Indesit Company

WGT837T

WGT837T/A

Általános jegyzet

1080150

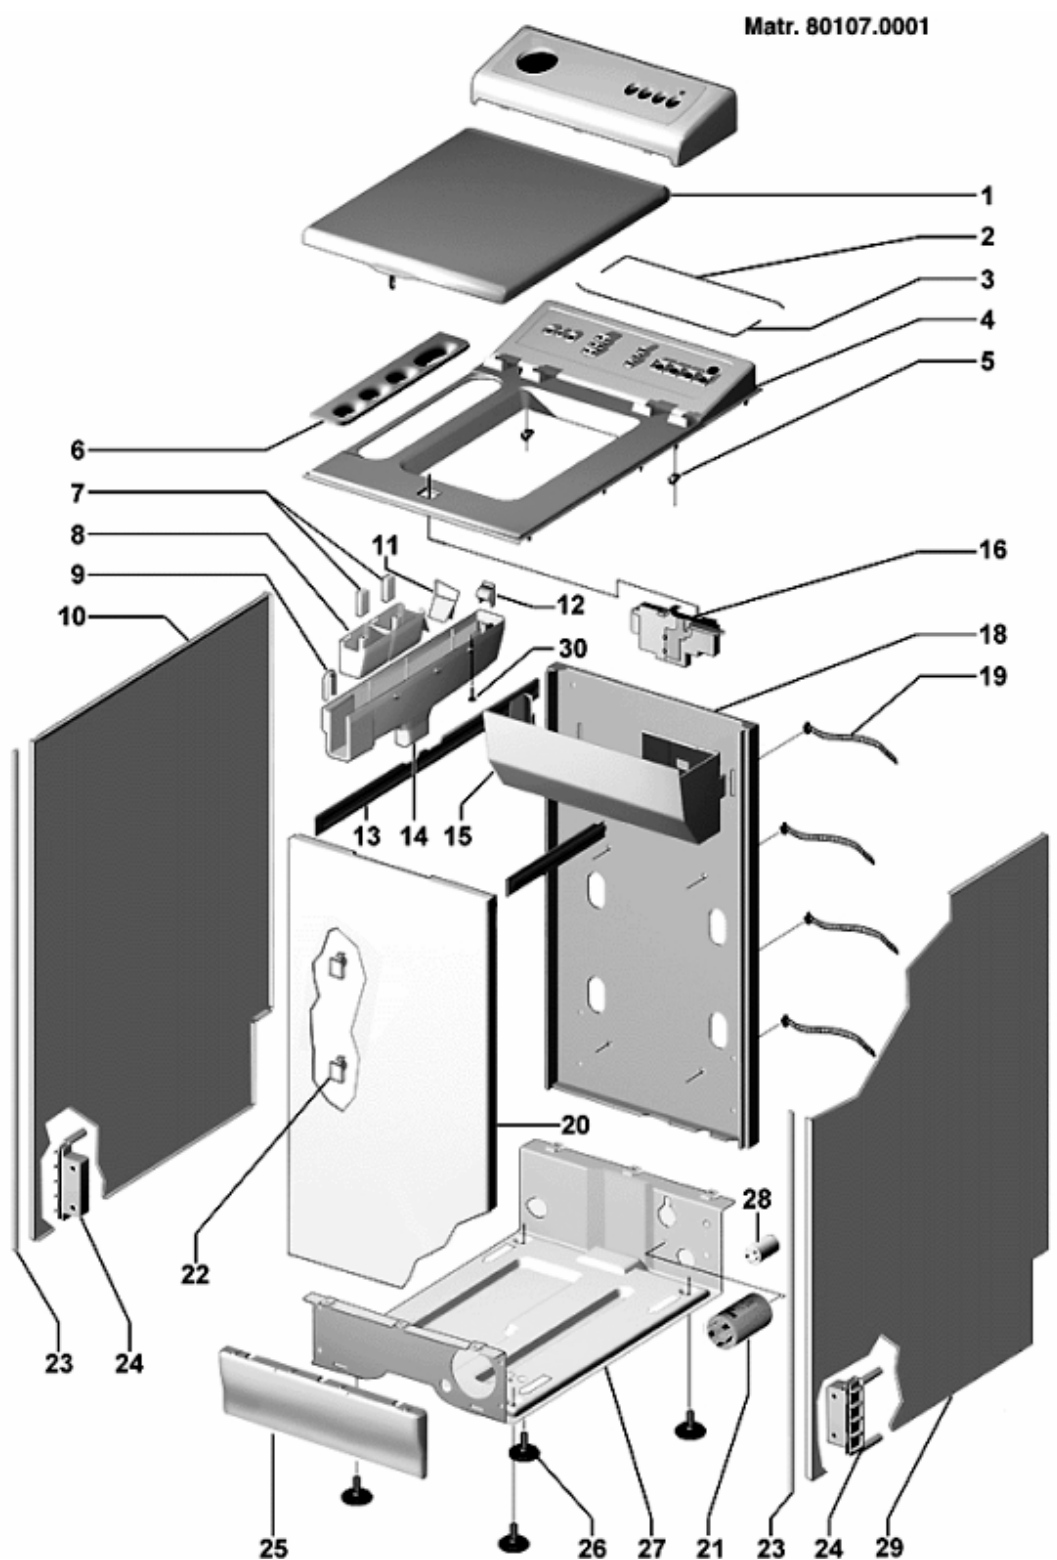
n1040044: Modifications to the Cabinet and to the detergent dispenser

Beginning with serial no. 90701.0001 on Top-Loading Washing Machines ranges ATL and WGT, some changes have been carried out on parts relevant to the cabinet and the detergent dispenser.

Part no. 051464 Replaced by 065068 Upper cross piece;

Part no. 051466 Control box Replaced by 065280;

Part no. 055288 Replaced by 065082 Inner lid;

Part no. 055294 Front panel Replaced by 065282 (The modified part can be used instead of the pre-modification one but not vice-versa);

1080250

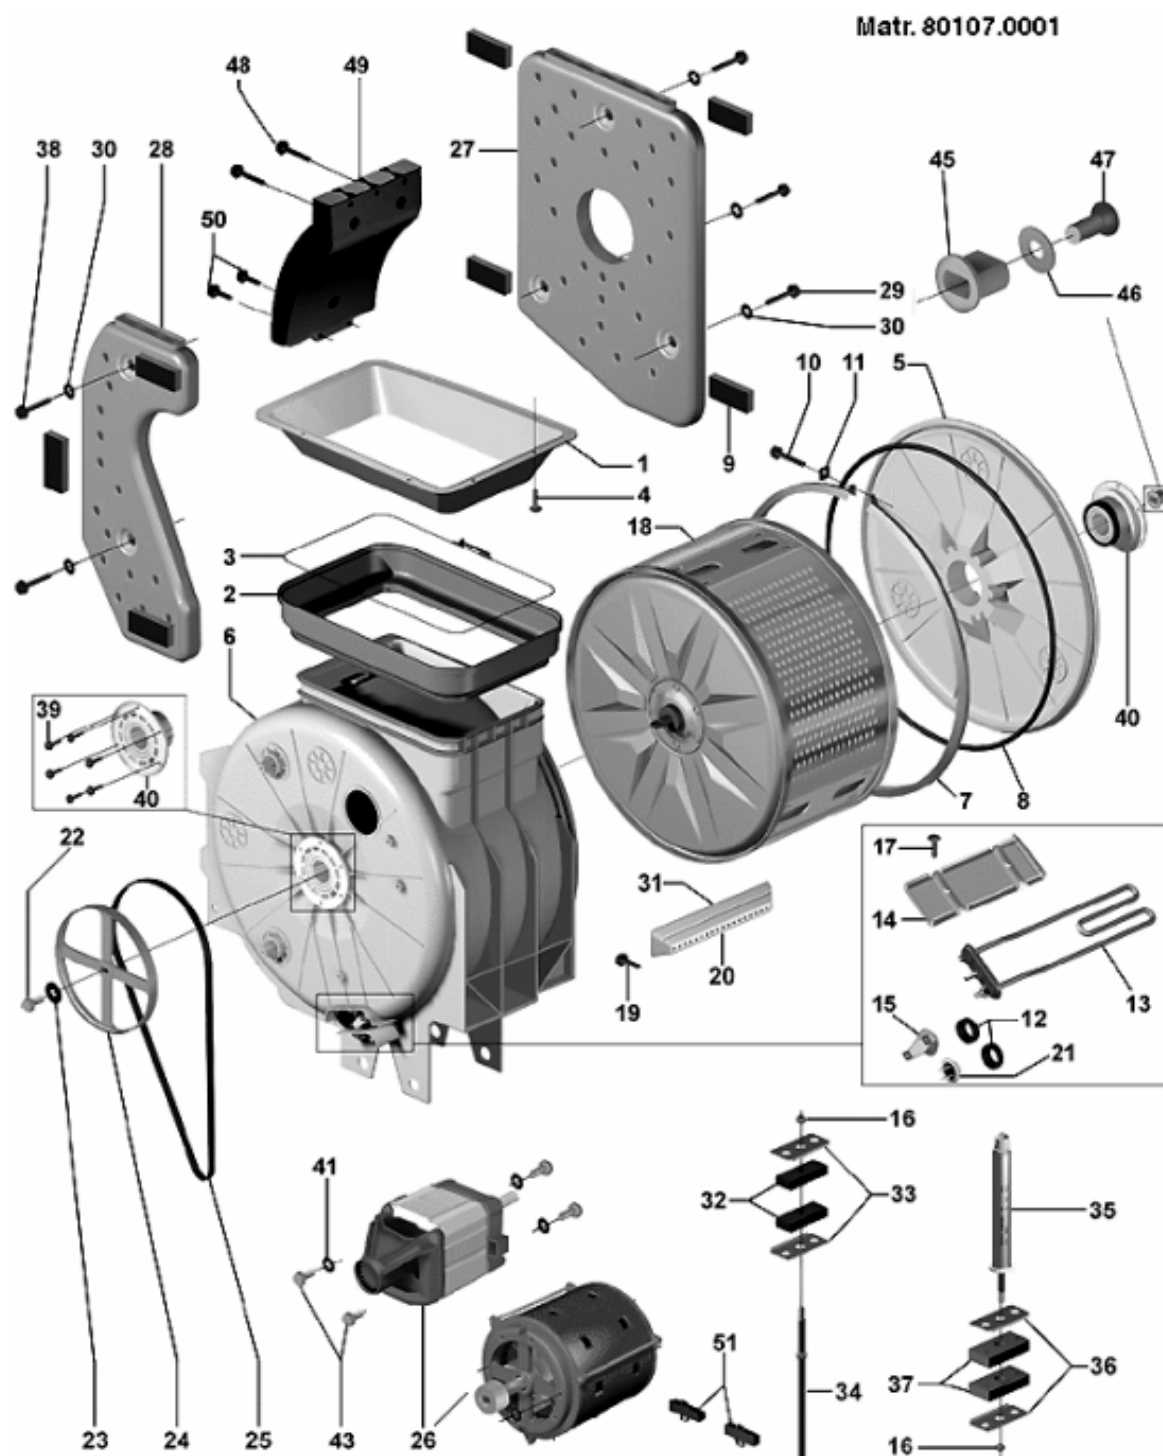
0108031:

Beginning with serial no. 807010.0001 (PH..9831..), a new sensor seal with part no. 058003 is being used in order to improve the sensitivity of the temperature sensor.

0108032: TUB BOTTOM STOP RING

Beginning from serial number 80914.0001 (PH..9838...) an axial stop ring with code 058468 has been introduced between the tub bottom and the counterweight in 800 rev. Top Loading Washing Machines.

n1040050: Replacement of drum doors on Top-loading ATL, WGT, TX models.

The drum door part no. 065735 is available from the Central Spare Parts Warehouse, which should be used on Top-loading washing machines in the ATL, WGT range manufactured at the Brembate plant.

n1040055: Thermal probe with stainless steel body on 800 rpm WGT appliances.

Beginning with serial no. 00110.0001 (Pl..0002.....), a new thermal probe with stainless steel body part no. 066348 and a new gasket part no. 066349 are being used on 800 rpm Washing machines from the WGT range.

n1040081: Indissoluble welded plastic tub.

Beginning with serial no. 00601.0001 (PH0022.0001), the oscillating assembly on top-loading washing machines WGT with the INDESIT brand with a plastic tub is being produced in a single assembly indissoluble welded part no. 075197 which is made up of the following parts:

If premodification appliances are being serviced for the replacement of the sensor, the old seal must be replaced with the new one.

The new parts can be used instead of the pre-modification ones (part no. 050574: Thermal probe with plastic body and part no. 058003: gasket) but not vice versa.

1080450

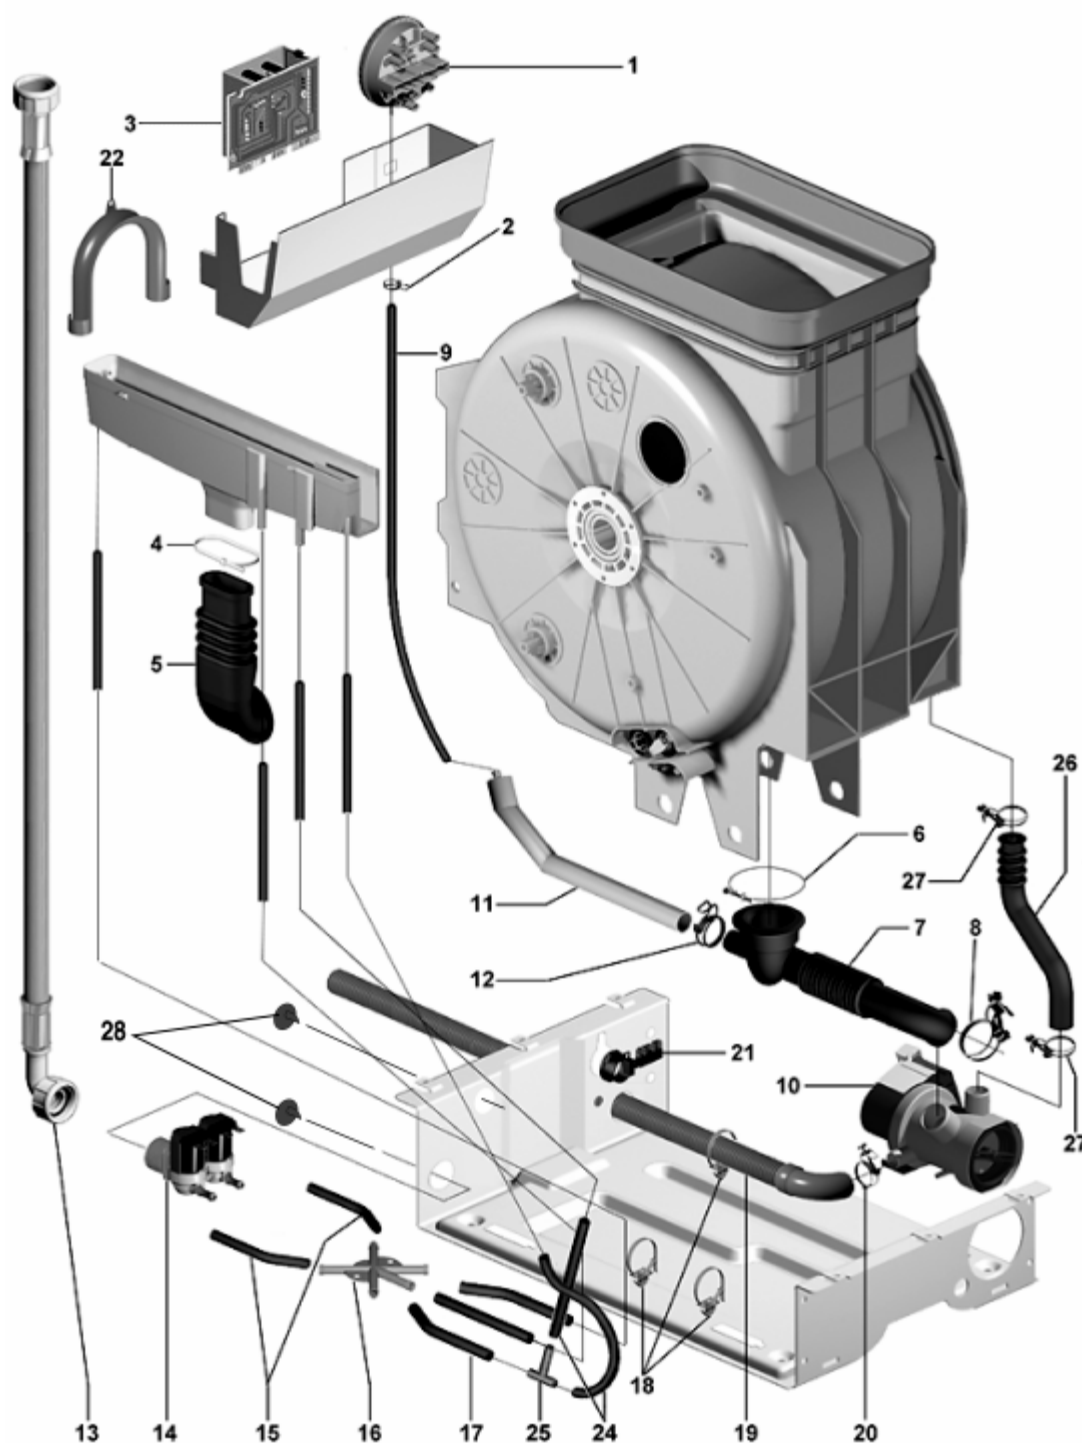
0108027: POLARIZED MODULES

Beginning with serial no. PF..9820., polarized modules have been used on the top-loading washing machines in order to eliminate any risk of errors in connecting the wiring.

0108030:

Beginning with serial no. PH..9829... on all of the top-loading washing machines produced at the factory in Brembate, the pressure switch with part no. 057527 is being used on all the 700/800/1000 rpm models, in place of the part with no. 051540.

0108033:

Beginning with serial no. 81012.0001 (PH..9842...) on the top-loading 800 rpm model washing machines produced at Brembate, a motor whose shaft diameter is 14 mm as opposed to 18 mm is being used.

The new pressure switch can be used in place of the pre-modification one, which will be handled until the stock has been used up.

The new parts are interchangeable with the pre-modification ones only if used as a complete assembly. The pre-modification parts will continue to be handled.
